FOR PERCOLATION TESTING AND SITE EVALUATION

RE: Percolation Test Report: 5434 Landing Road; A545043

CAMPBELL PROPERTY
5434 LANDING ROAD

TITLE:
PERCOLATION CERTIFICATION PLAN
A545043

LOCATION DIAGRAM

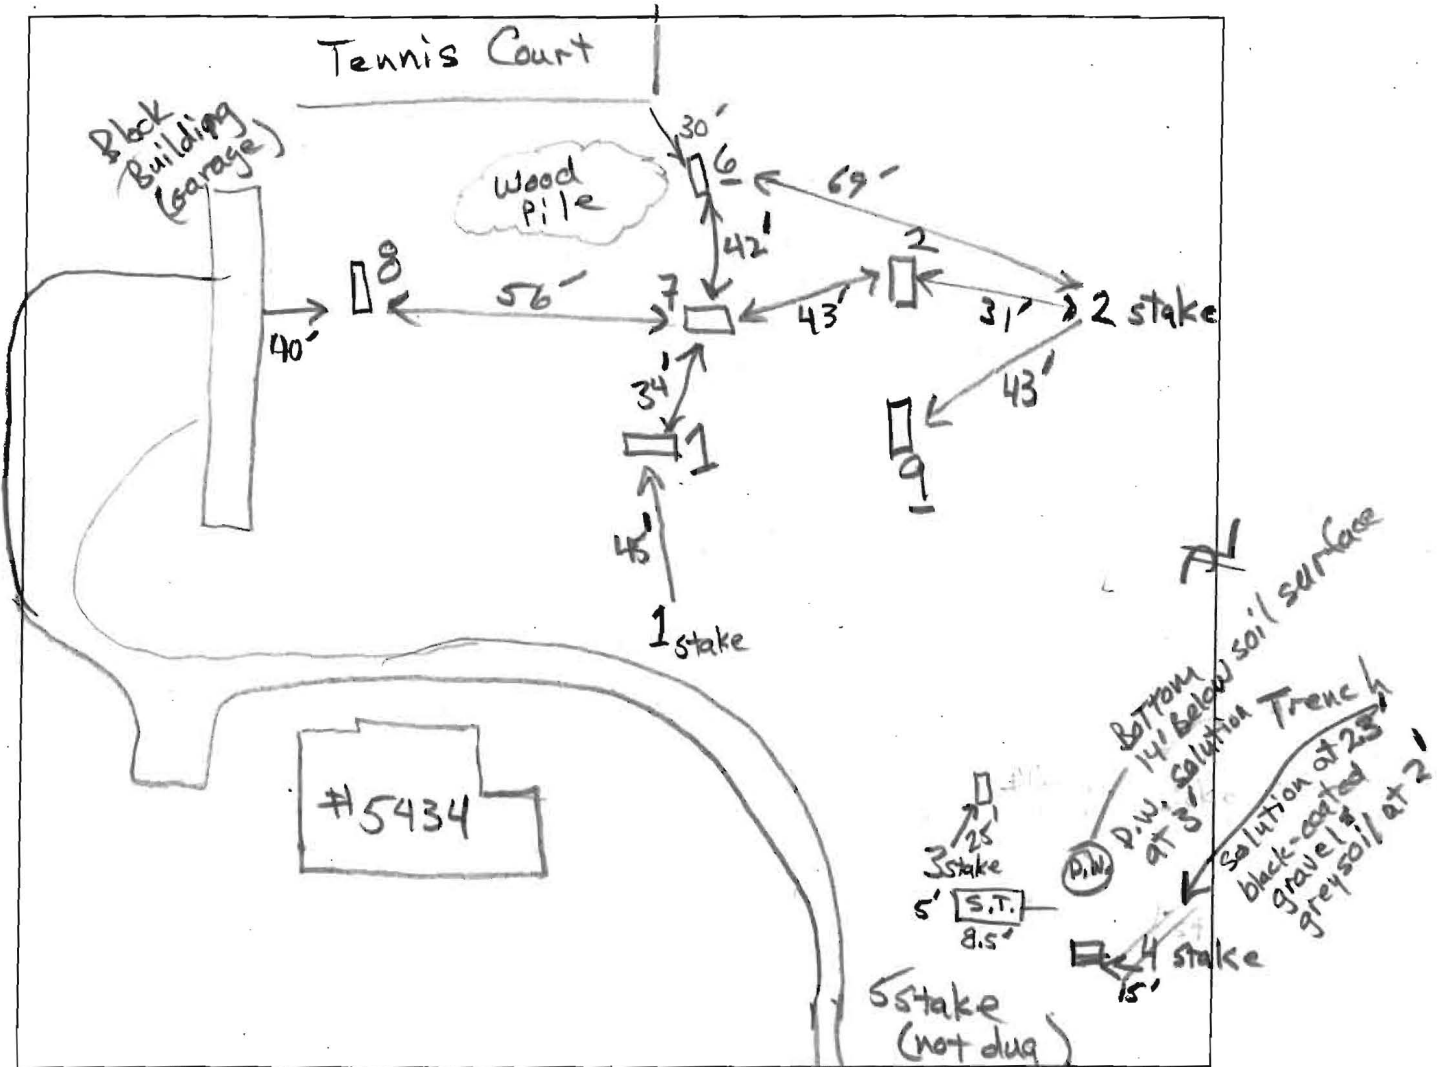
PROPOSAL: Sketch of Perc Test locations; #6, #7, #8 & #9 added
#1, #3 & #4 FAIL; #2, #6, #7, #8 & #9 PASS

COMMENTS: Septic Tank approx 5' x 8.5' estimated 1500 gallon. Landing Road
Dry Well does not appear to be used; cinder block walls
3 feet depth of solution, prob. groundwater.

Trench on verge of failure; water table at 6.5' to 7'

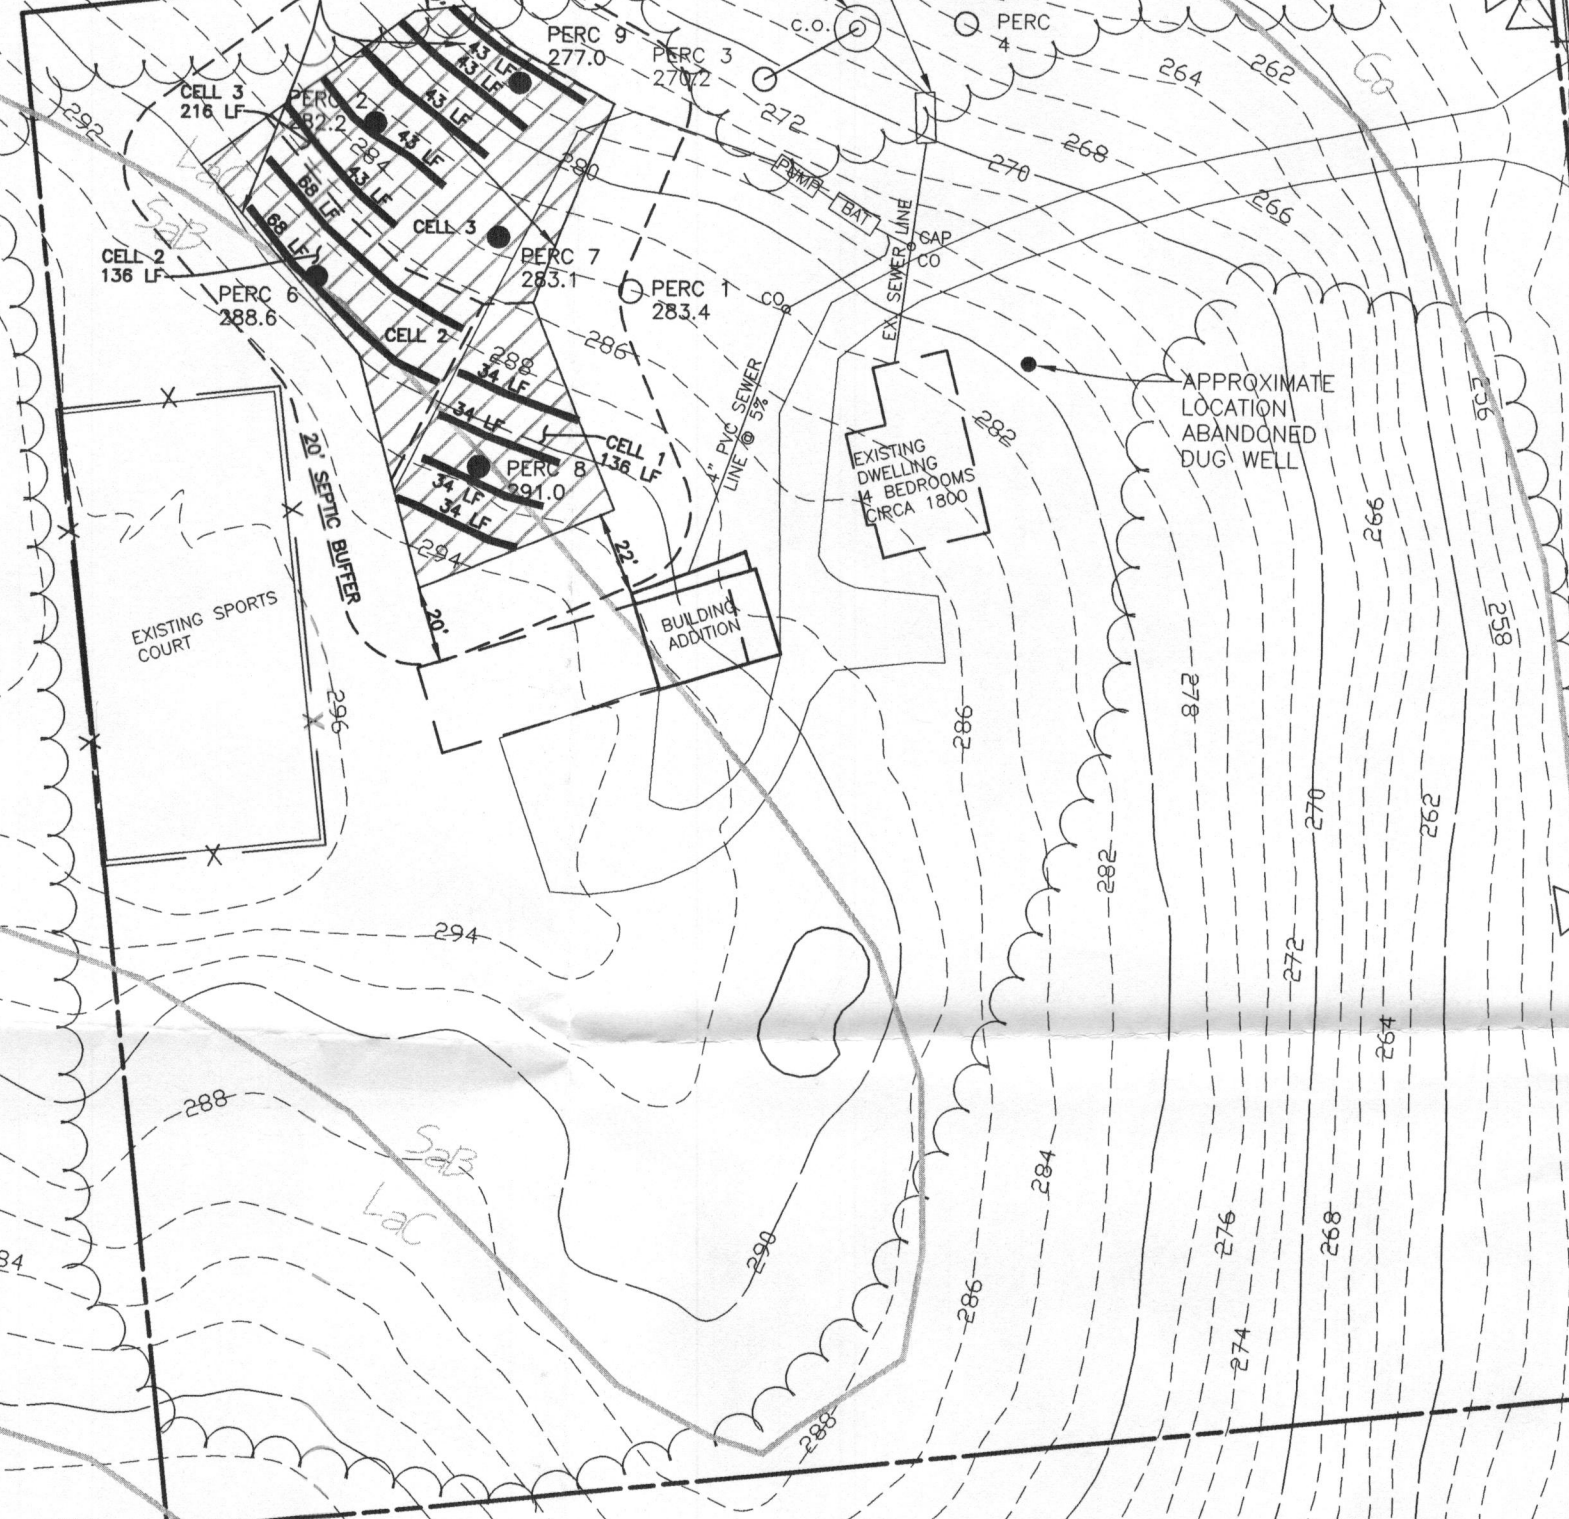
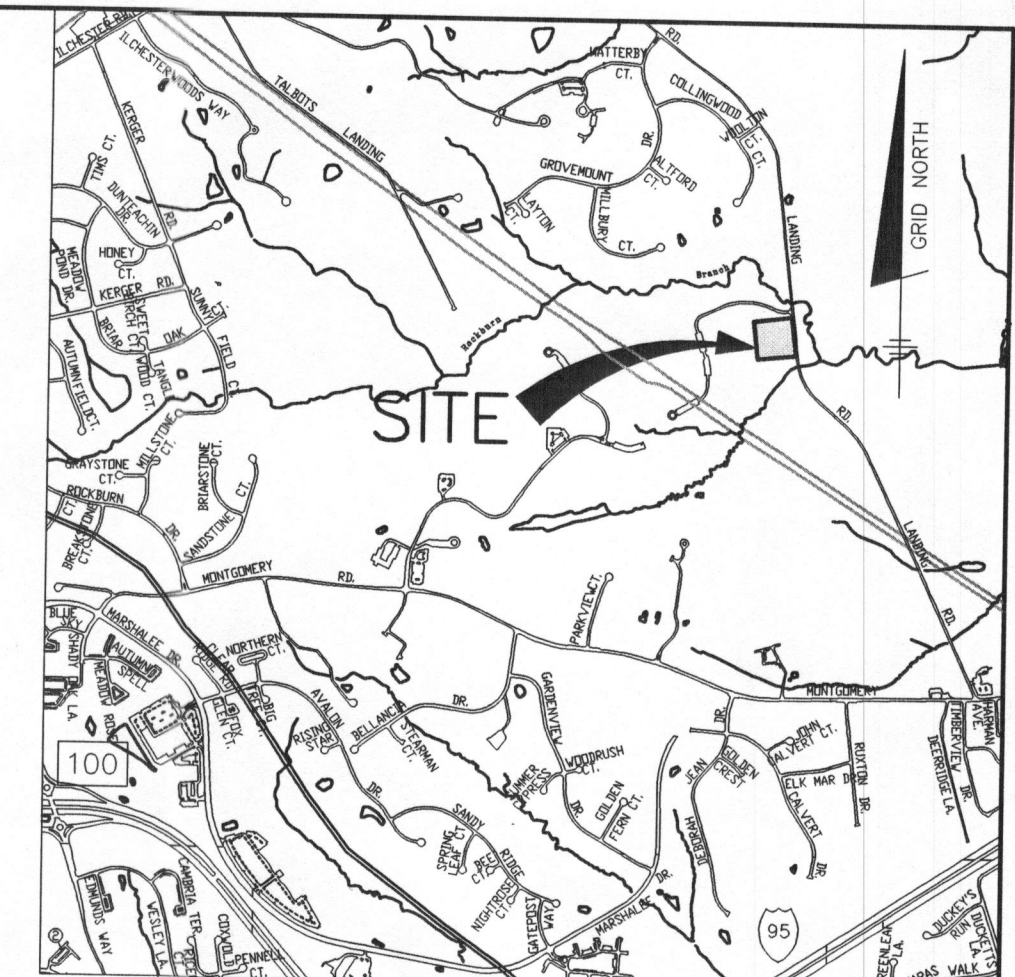
groundwater. Prior to Health Department approval of the planned improvements on the subject property, both the septic tank and the dry well are to be properly abandoned and replaced.

Shallow rock was encountered at locations '1' and '3', at 5.5 ft. and 3.8 ft., respectively. Near staked location '4', the existing trench was uncovered: black-coated 3-inch gravel was encountered at 2 ft. depth and there was a solution standing in the trench at about 2.3 ft. depth. The depth of the trench was not explored as this would likely have resulted in failure requiring immediate replacement. An observation hole was dug about 10 feet uphill of the trench. Water seeps and morphological indicators of water table were observed at 7.8 ft depth. The trench has reached the end of its serviceability; a replacement drainfield is needed. Locations '1', '3' and '4' FAIL as there is not a 4 foot buffer to water table, or bedded rock, from the depth that a trench would have to be installed. Location '5' was not dug.

Test location '2' was dug 31 feet from the staked location and PASSES. The boundary of approvable area near '2' is defined by an approximate 10-foot setback to a drainage channel. Beginning at the back of the tennis court, the drainage channel is about 1 foot wide and several inches deep, and bisects the northwest corner of the lot, then runs past the trunk of a large chestnut tree before ending near the property line at stake #2. The topography of the northwest corner of the lot has a rolling characteristic, apparently shaped by 'cut-and-fill' to create a flat area for the tennis court and a drain for surface runoff. As such, it is unsuitable topography for a septic system drainfield.

Four additional test locations were added: '6', '7', '8', and '9'; all PASS. Location '7' should be avoided when locating drainfields as the soil profile is not as deep as the other locations, limiting trench depth to 6 feet. Locations '6' and '8' represent an area in which a drainfield having trench depths to 7.5 feet may be located. Locations '6' and '2' represent an area where the trench depths may range to 8 feet depth. Trench depths may be 7.5 feet in the area represented by locations '2' and '9', the lowest elevations of approvable area.

The septic tank and a dry well were exposed for observation. Judging by its dimensions (~5' x ~8.5'), the septic tank capacity is 1000 gallons, meeting code requirements for a 3-bedroom residence. The septic tank has only a single compartment which does not meet current code requirements.

The dry well is constructed of cinder block. It has a concrete cap about 3 feet below soil surface, and the bottom of the dry well is at 14 feet below the soil surface. Three feet of solution was in the dry well at the time of observation. As the elevation of the water surface in the dry well is about equal to the elevation of water seeps at location '4', I assume that the solution is

At this time, best available technology (BAT) systems must be installed with all septic system upgrades in Maryland. Information concerning approved technologies and BAT unit characteristics is available on the Maryland Department of the Environment website. I recommend that the BAT unit discharge by gravity to a 1500-gallon pump chamber.

Due to the coarse properties of the subsoil in the area approvable for sewage effluent disposal, all drainfields must be designed as low-pressure distribution systems.

Signature approval of a Percolation Certification Plan is needed to release the septic system installation permit for upgrade. If you have any questions regarding this evaluation or requirements for a Percolation Certification Plan, please contact me at the above address or by calling (410) 313-2691.
